Your Ref:
Our Ref: S13111-JNP-XX-XX-CO-C-1002/SLL

Re: 25/01016/FUL AND 25/01030/FUL - Former Pink Drips Unit Sandbrook Park Sandbrook Way Rochdale OL11 1RY

We refer to your comments on the above application dated 15th July 2026. The comments below address the points raised.

GPR Survey

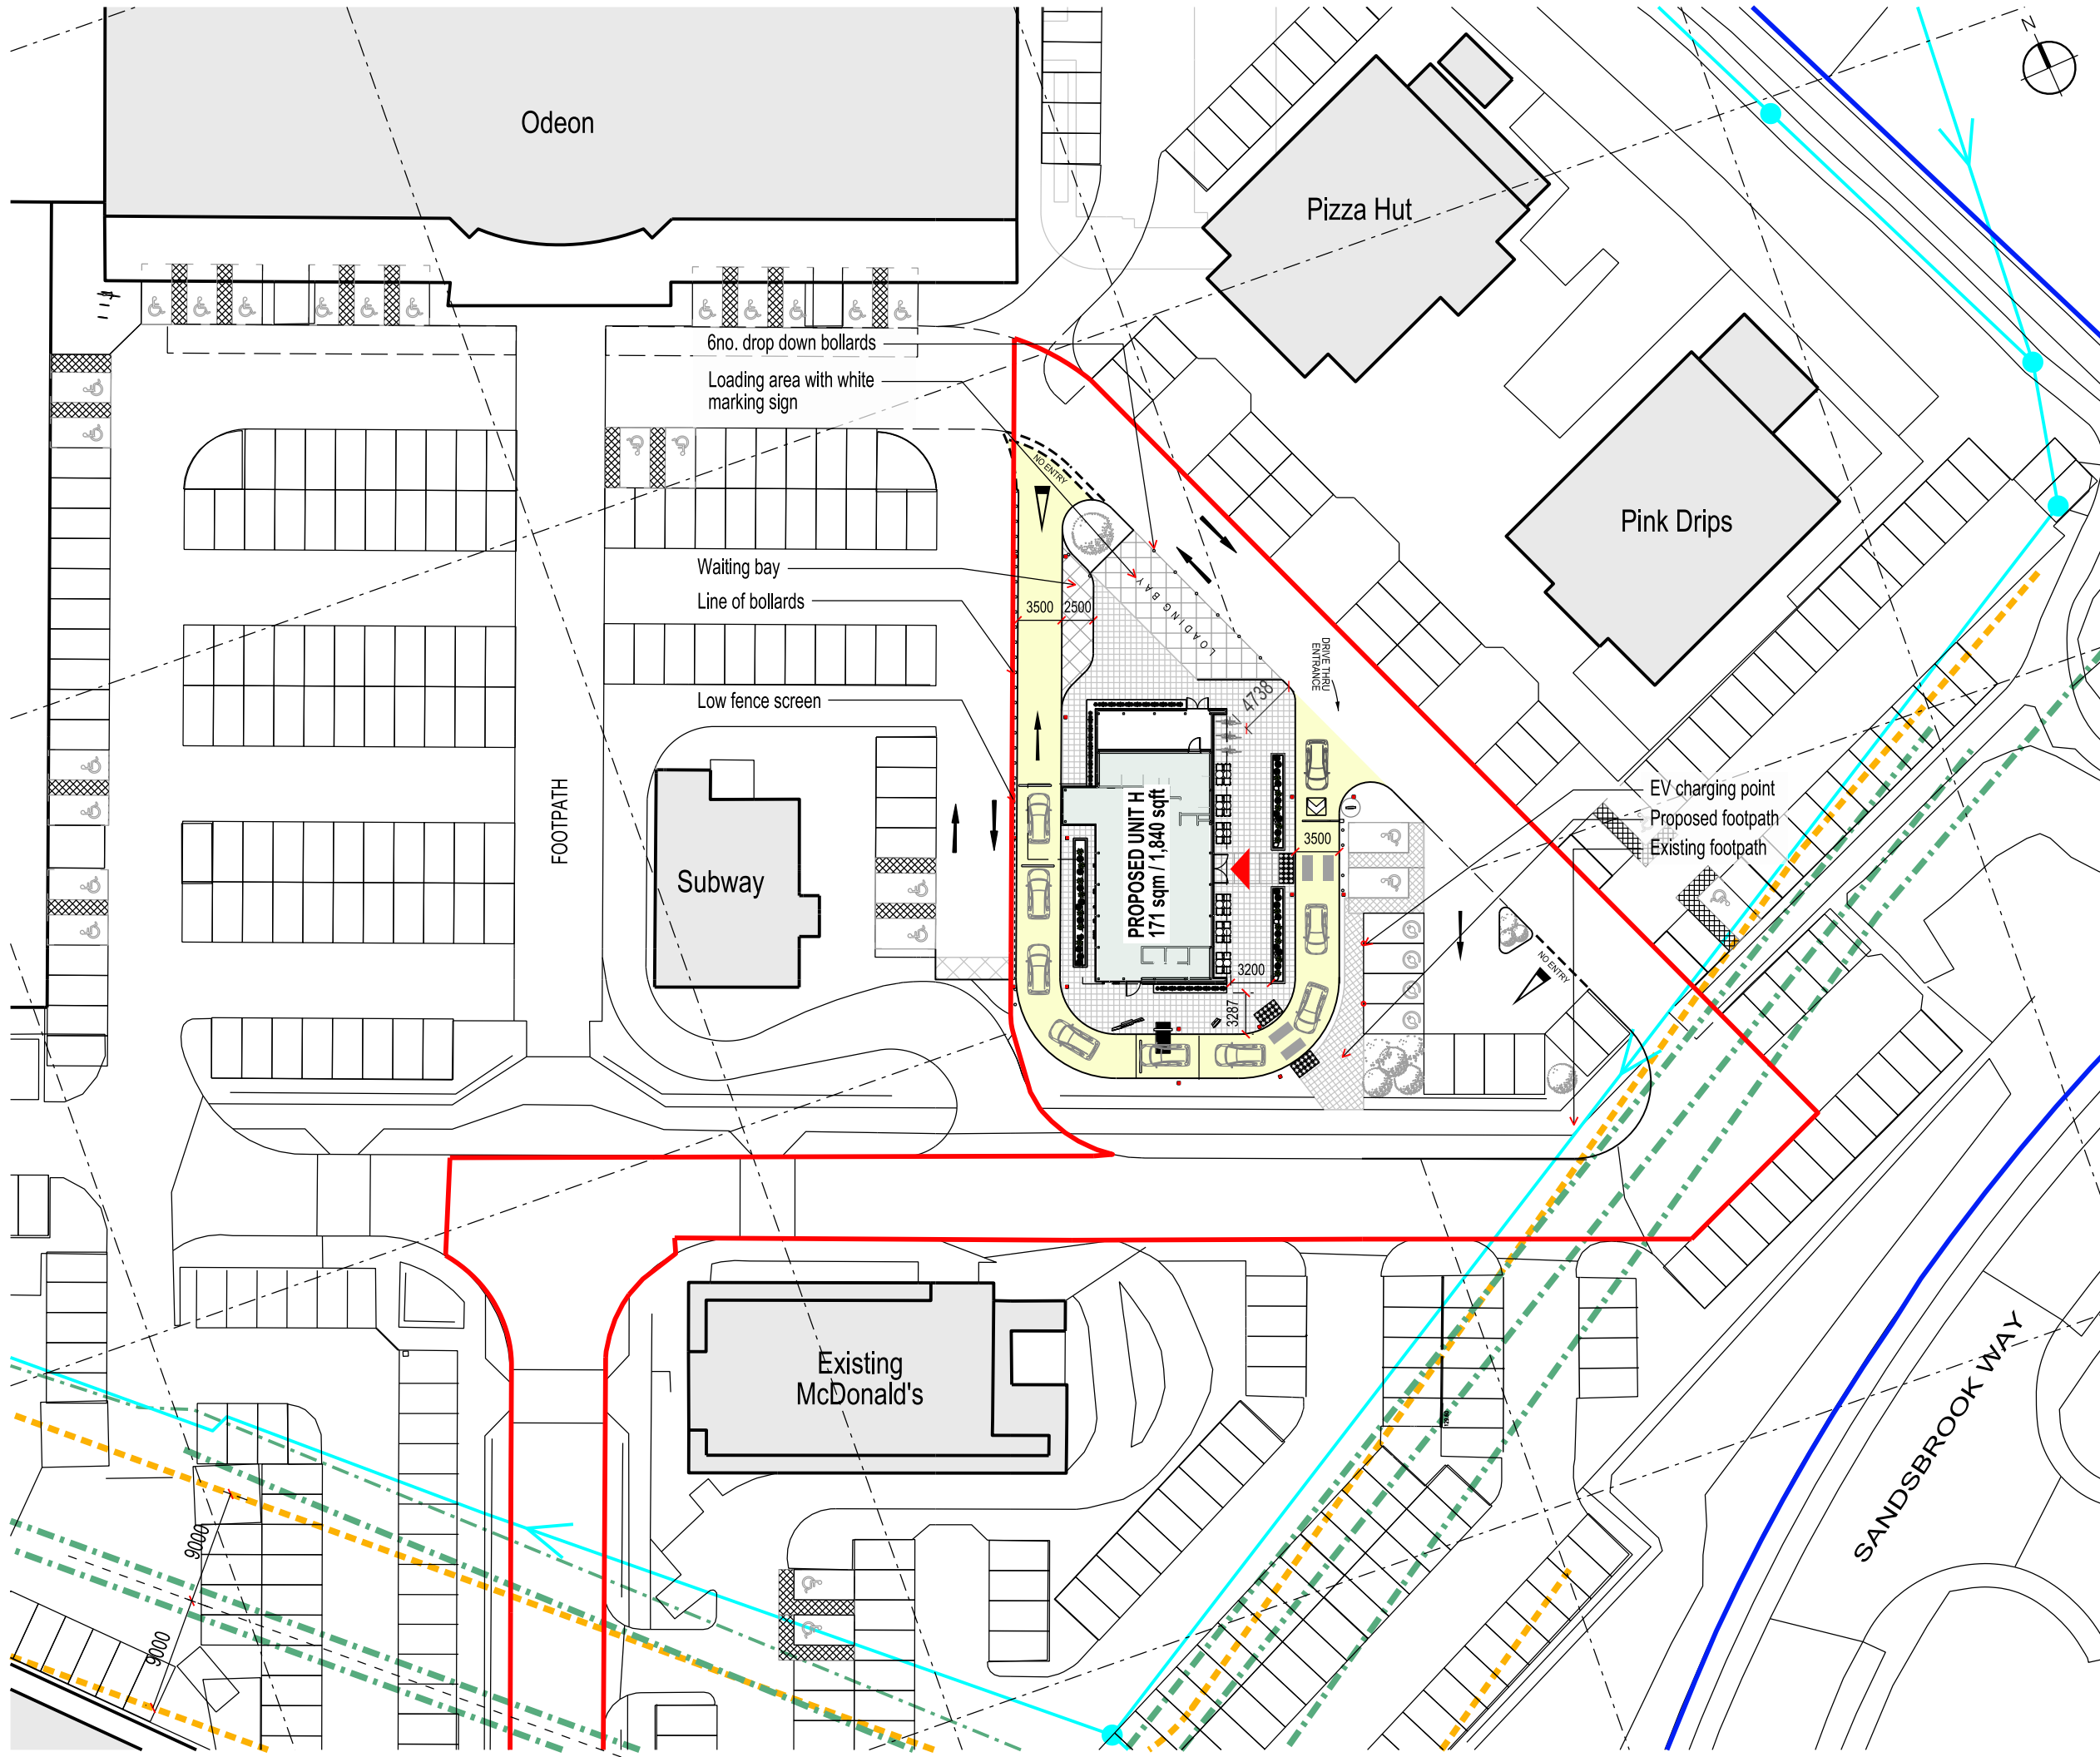
1. Final outfall destination for the surface water discharge
 - A GPR survey was undertaken for the site and is reattached in Appendix A. The surveyors also lifted the manholes on the surface water system to confirm the depth of the chambers.

- The GPR survey shows a 225mm surface water sewer flowing to the south east in the south eastern area of the site, entering a “culvert”, with the depth noted as 5.58m just to the south of the foul water sewer. Noting that the foul water sewer shown on the GPR survey is incorrectly identified as a foul sewer, as the line type in the United Utilities asset mapping in Appendix B of the Flood Risk Assessment and Drainage Strategy shows it to be a combined sewer.

- This would confirm that the “culvert” shown on the GPR survey is the culvert shown on the Starbucks plan.
 - This location is consistent with the location of the culverted Sudden Brook.

- This demonstrates that the existing drainage regime is therefore discharging to this culvert which is aligned with the GPR survey.
 - The proposed surface water drainage strategy for the site proposes to discharge into an existing manhole in the surface water drainage network upstream of the ultimate discharge to the culverted Sudden Brook.
